# Bradley Heights Apartments

## A 236-Unit Apartment Development Puyallup, Washington

### Bradley Heights SS LLC

17 WINDOW INSTALLATION WITH WOOD TRIM  
NO SCALE

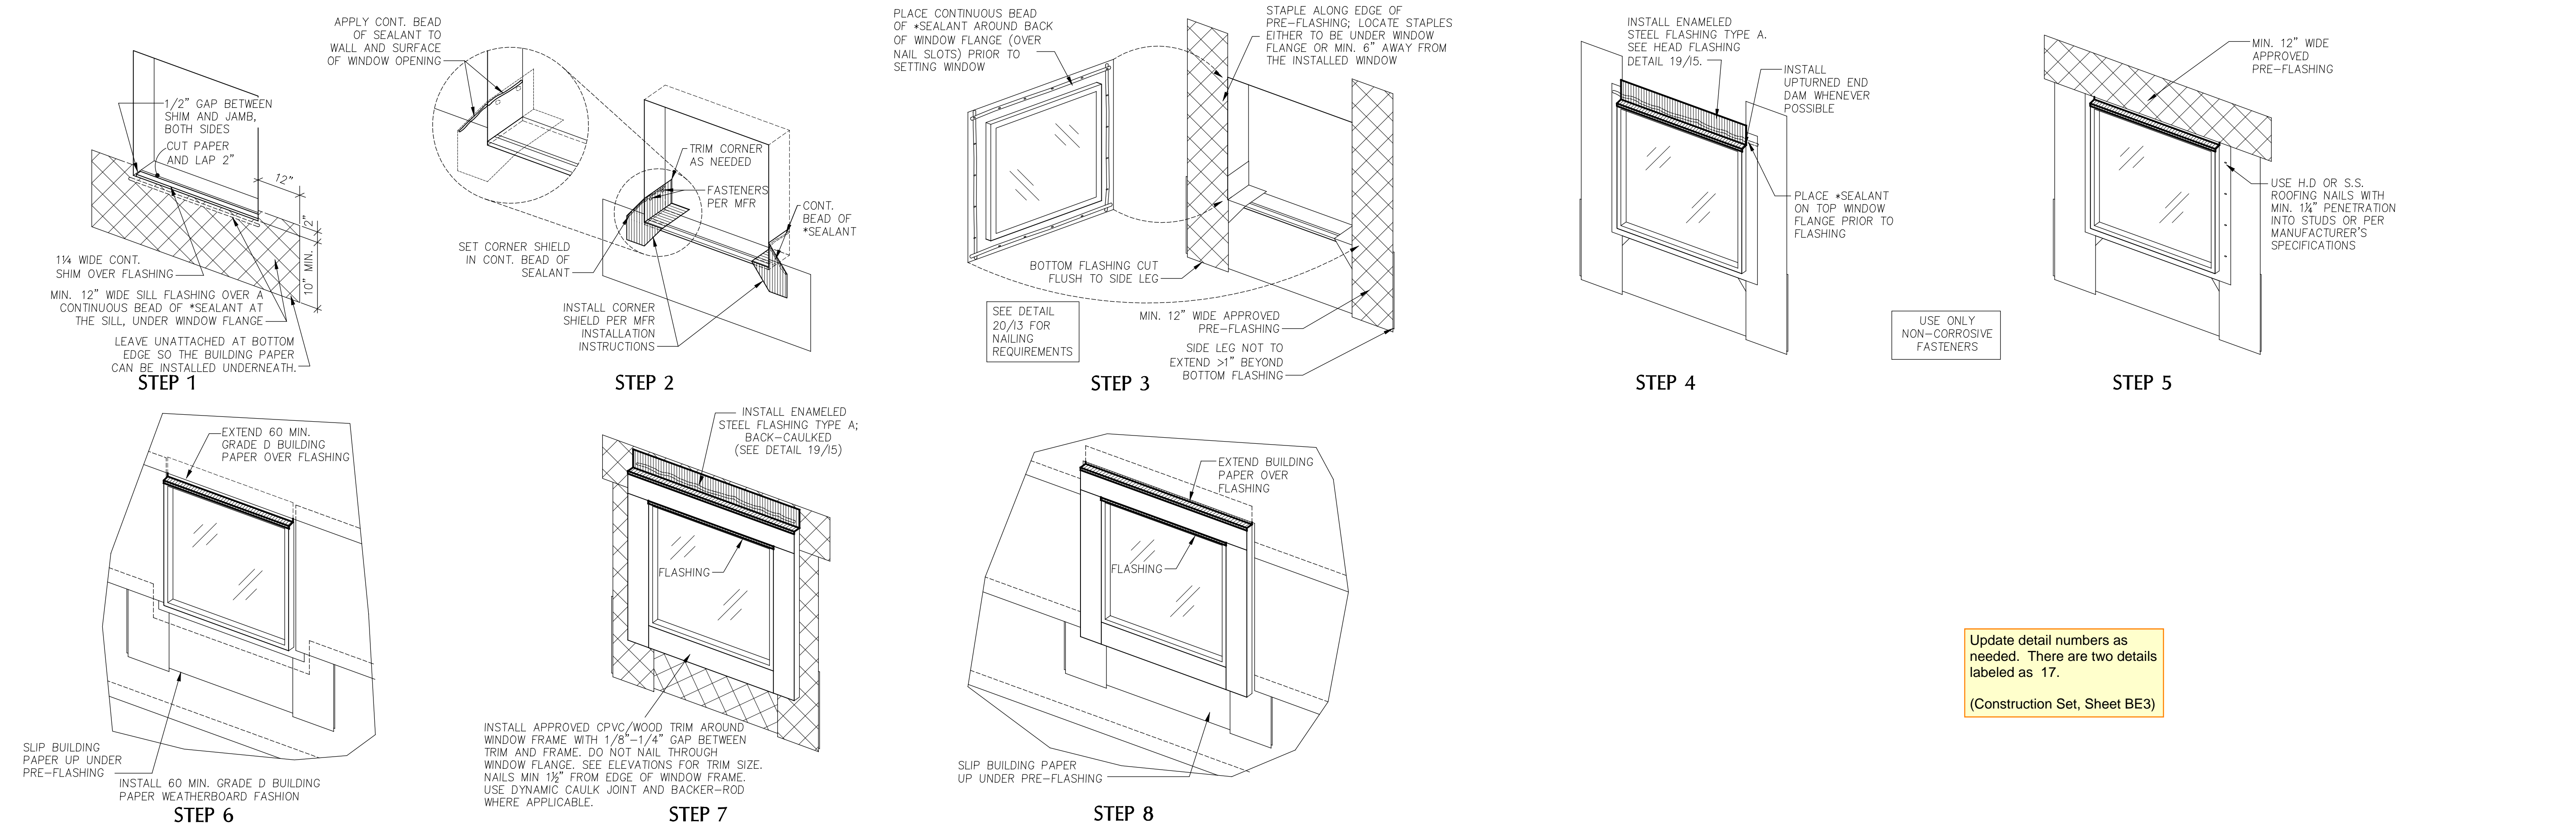
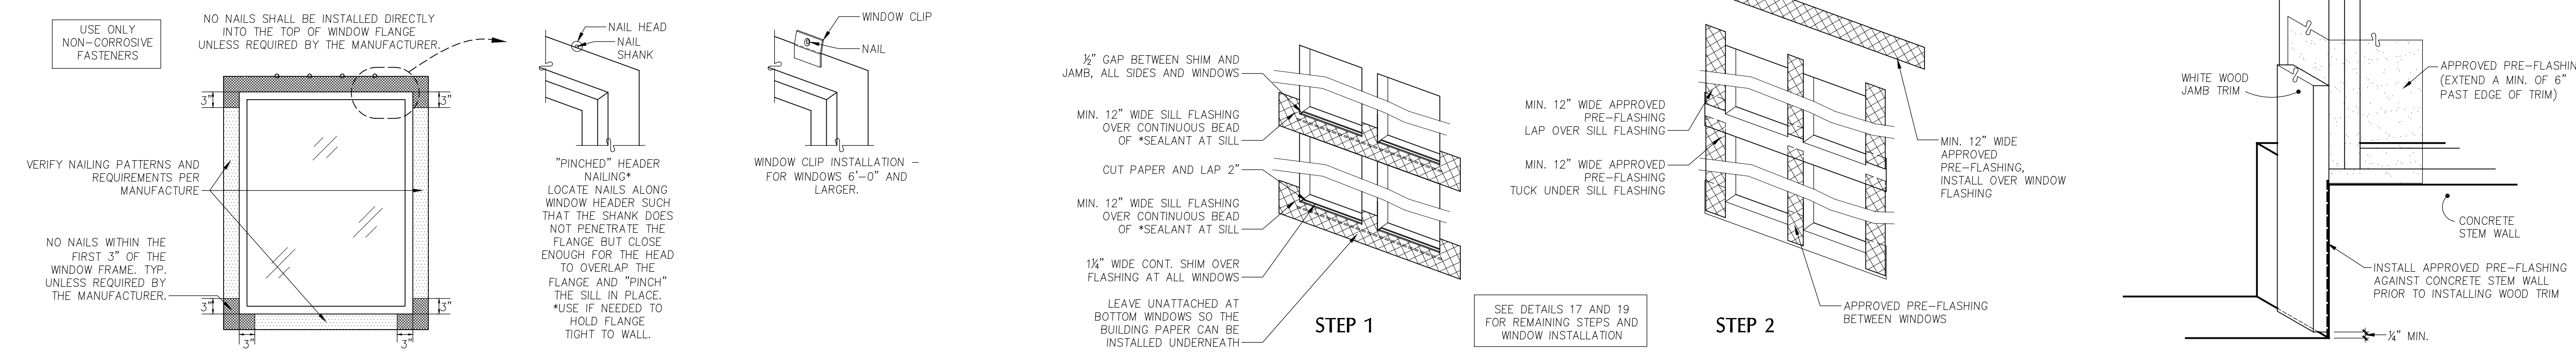
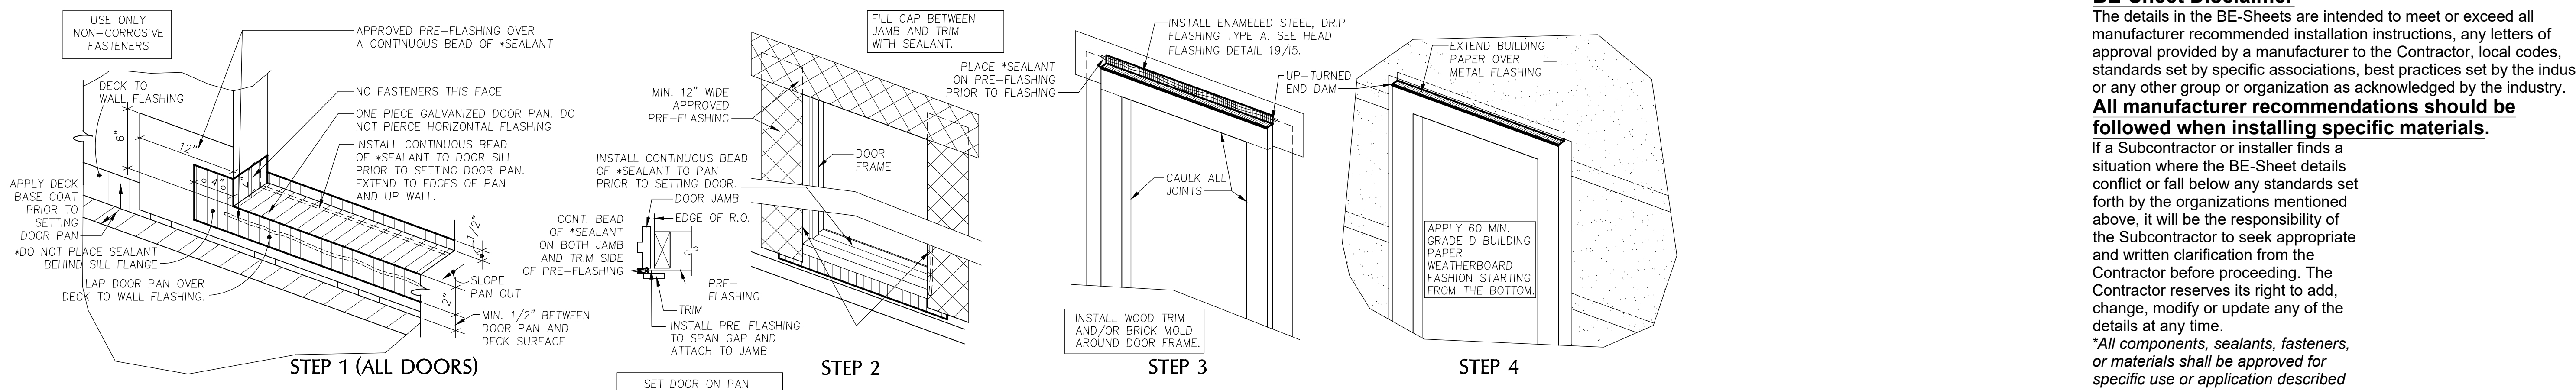
Update detail numbers as needed. There are two details labeled as 17.  
(Construction Set, Sheet BE3)

BUILDING F  
BASEMENT LEVEL PLAN  
1/8" = 1'-0" 3/4 SPLIT LEVEL, 28-UNIT BUILDING

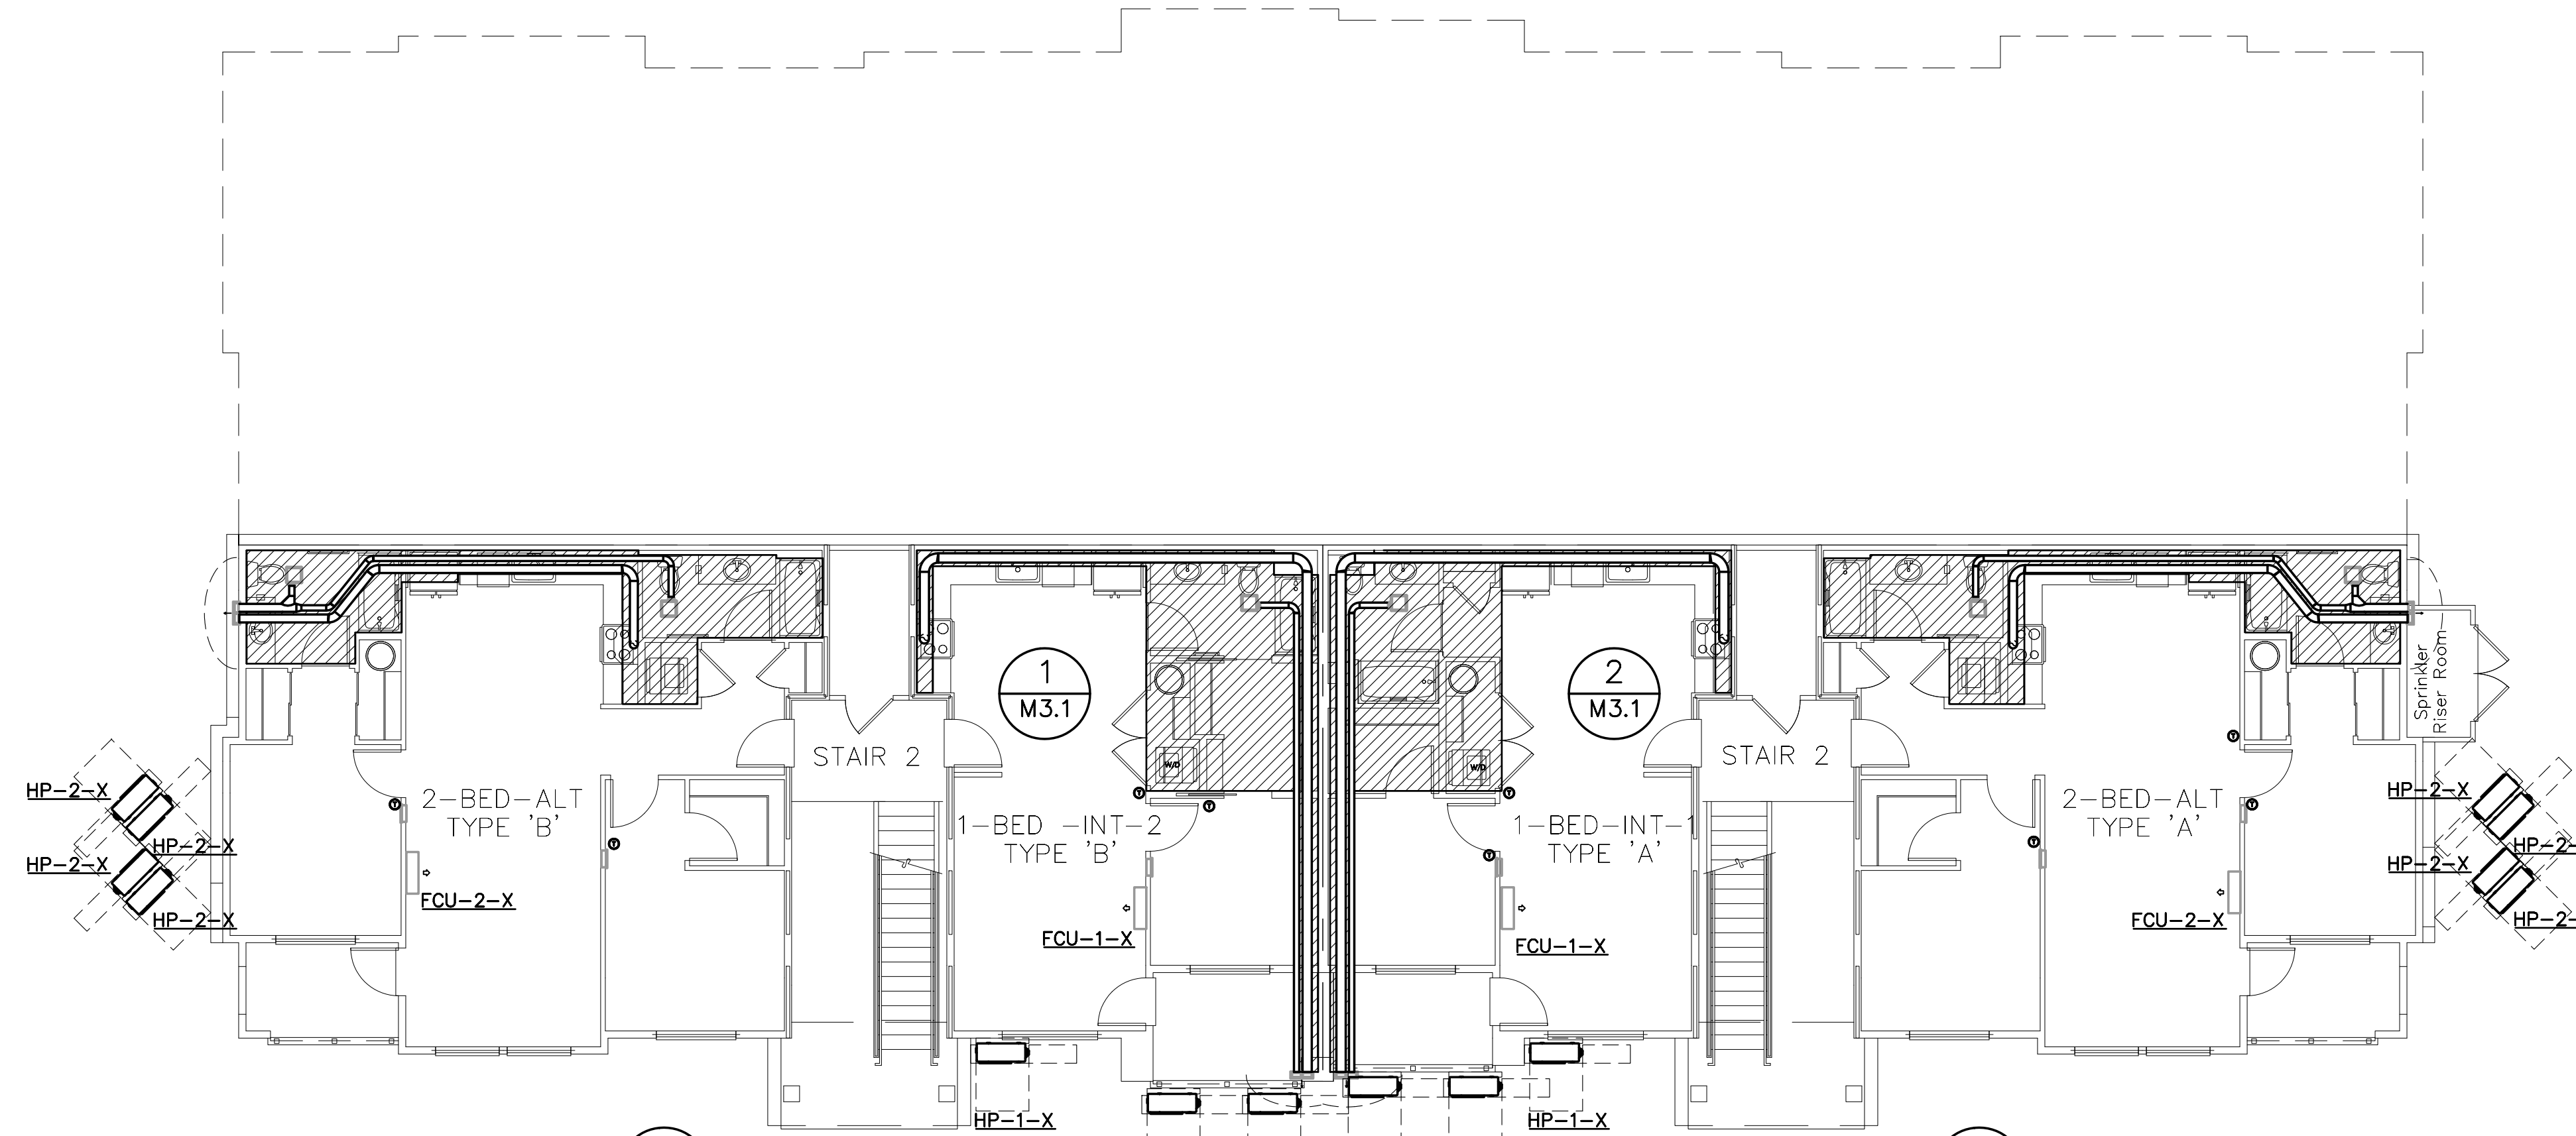
Duct runs for range hoods on interior units appear to be about 63 feet. Provide specifications on range hood that will accommodate a long run.  
(Construction Set, Sheet M2, M2.1 and M3.1)
